# UNITED STATES PATENT AND TRADEMARK OFFICE

**Office Action Summary**

**DETAILED ACTION**

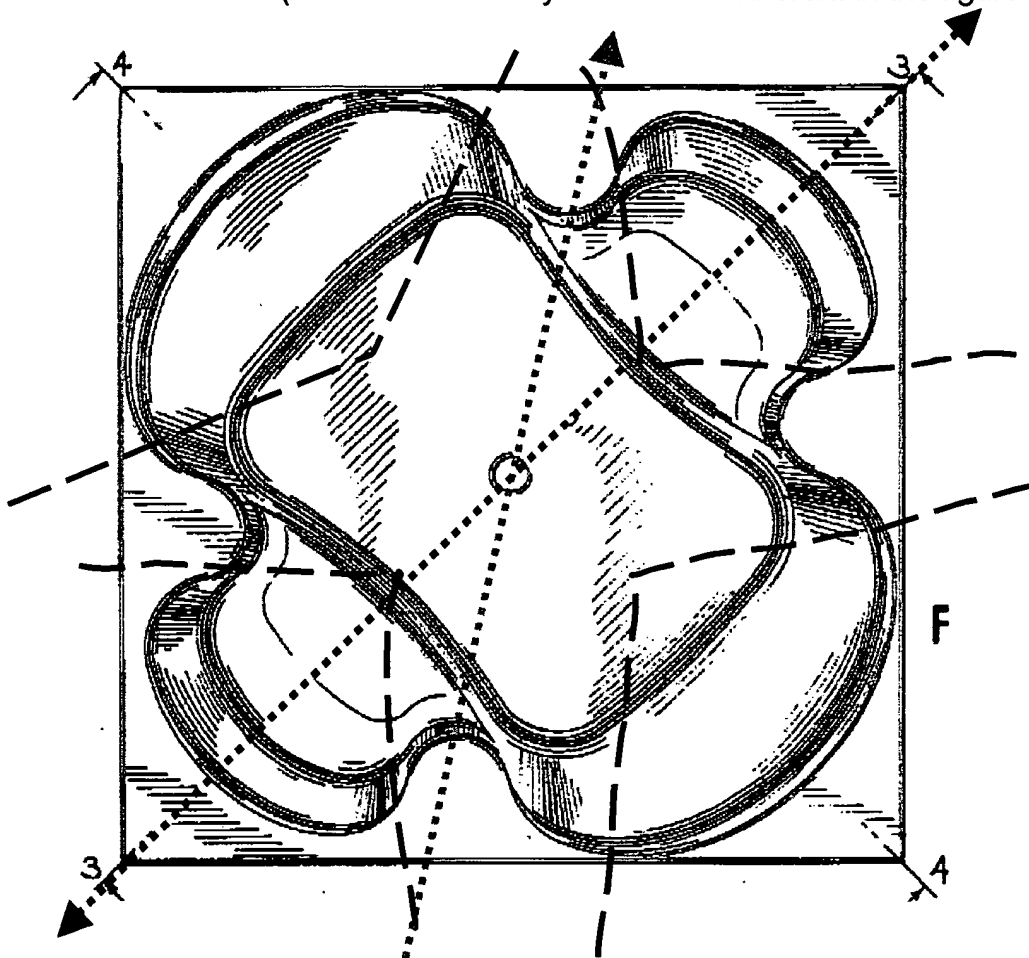
- a top edge defining a shape of the spa shell, the edge having 4 rounded concave relative to the interior corners (see marked up Fig 2 below—4 corners are marked off by examiner in dashed lines) each corner having a radius that exceeds 12 inches (inherent, as the smaller opposed corners clearly are formed as seats, and a drain is also shown to give proportions clearly in excess of 12" radius for each curved corner) and
- four curved exterior side walls that are convex relative to the interior, each wall connected between two of the concave corners (between areas marked off as

dashed lines by examiner). Note that the walls are clearly shown as exterior sidewalls in Fig. 3 and 4:

- Wherein the top edge is substantially symmetrical both about an axis that bisect the interior through two side walls (orange dotted axis by examiner- -inherent in the figure shown) and
- substantially symmetrical about an axis that bisects the interior through two corners (blue dotted axis by examiner --inherent in the figure shown).

Re claim 14: The drainhole shown is considered a water feature, as water drains through it.
